Full Council Meeting – 2nd June 2022

Item 8: Coneburn Attachments

| | Page |
|---|------|
| Attachment C – Beale Consultants – Coneburn Industrial Zone Ecological Peer Review | 69 |
| Attachment E – Stantec Technical Review Coneburn Industrial Review – Change to Land Use Coverage | 77 |

Figure 2: QLDC Proposed District Plan Decisions Version Coneburn Structure Plan.

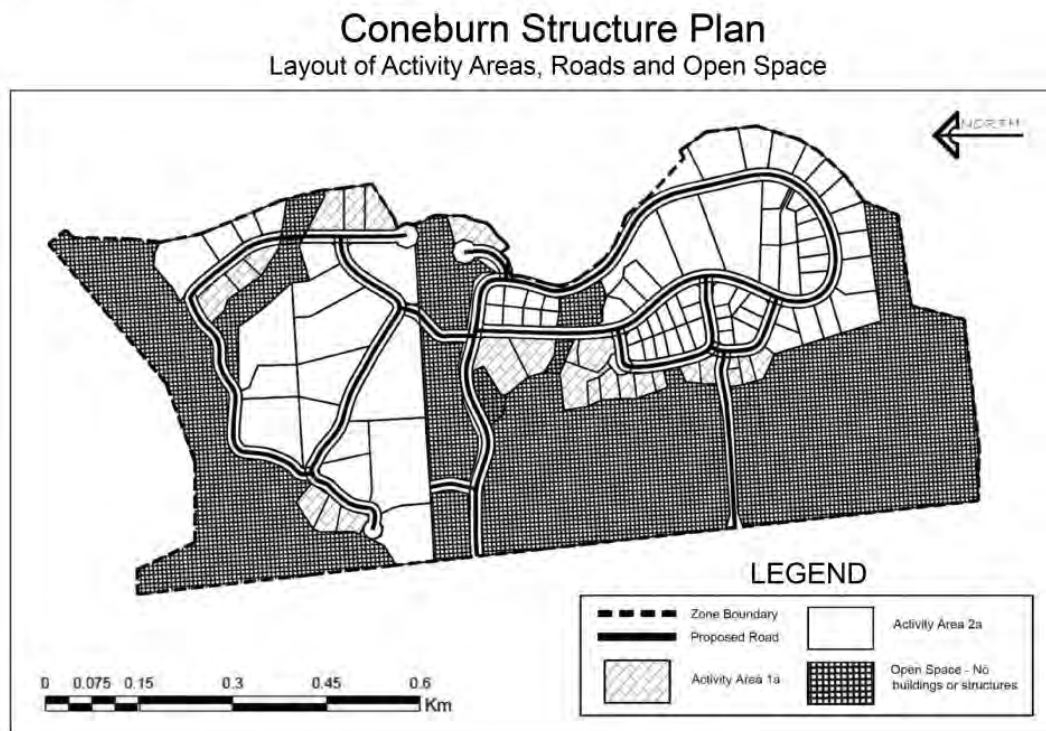
- 3.4 It should be noted that the DV Coneburn Structure Plan (**Figure 2** below) anticipates *Open Space - No buildings or structures* land use within this part of the Coneburn Industrial zone. Therefore, amending the UGB or ONL boundaries to better align in the part of the zone will not impact on the potential for development within the zone.

Figure 4: Debris flow/flood diagram indicating effect of slope on flow type. Red zone is likely to be consistent with Coneburn development conditions. After BGC (2020)³.

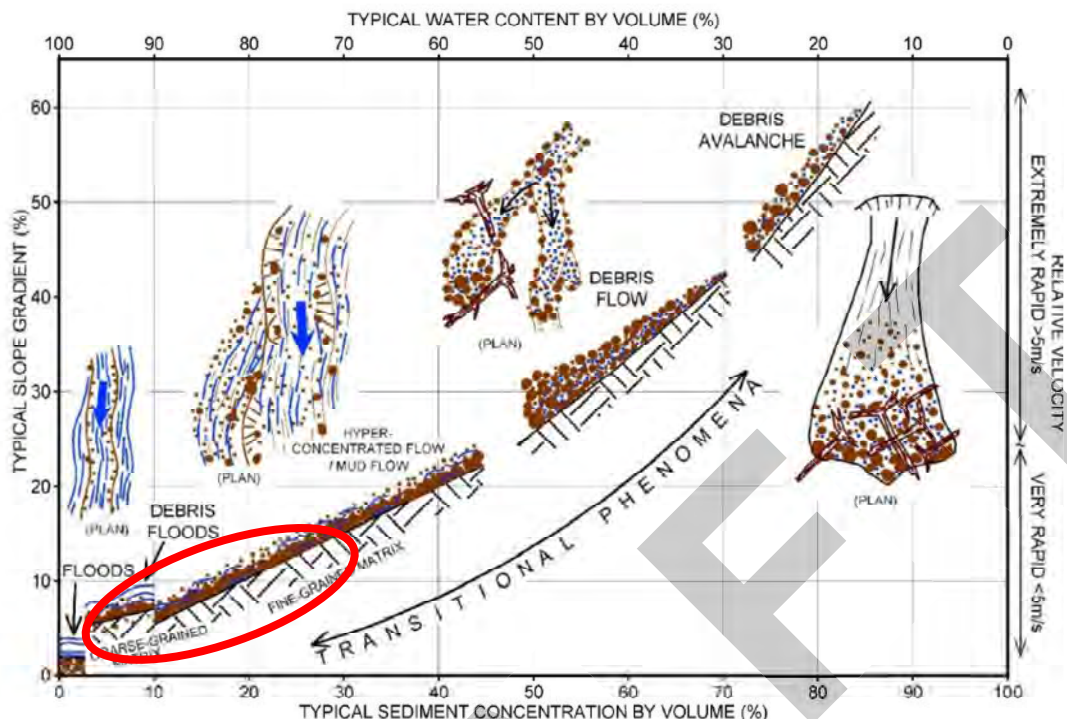
- It is difficult to represent the many uncertain variables in a debris flow/flood event scenario (water flow, debris volume, type, speed debris enters the water flow, percentage of debris etc). Geosolve's conclusions regarding the potential for debris flood (not debris flow) are consistent with empirical studies, including a separate source shown in Figure 4.

- We concur with the assessed risk by Geosolve. However, the debris flood model is considered preliminary as stormwater and conveyance structures will be developed during detailed design, requiring additional assessment. We agree that debris flood is possible and mitigation will be necessary for the proposed development. It is good engineering practice to mitigate the effects of natural hazards to as low as reasonably practicable, especially due to the inherently uncertain nature of debris-related hazards. Detailed design will occur at the Resource Consent stage and may take the form of training or containment structures (engineered earth and/or concrete) along the margins of susceptible creeks, and possibly on the upslope boundary of the proposed development.
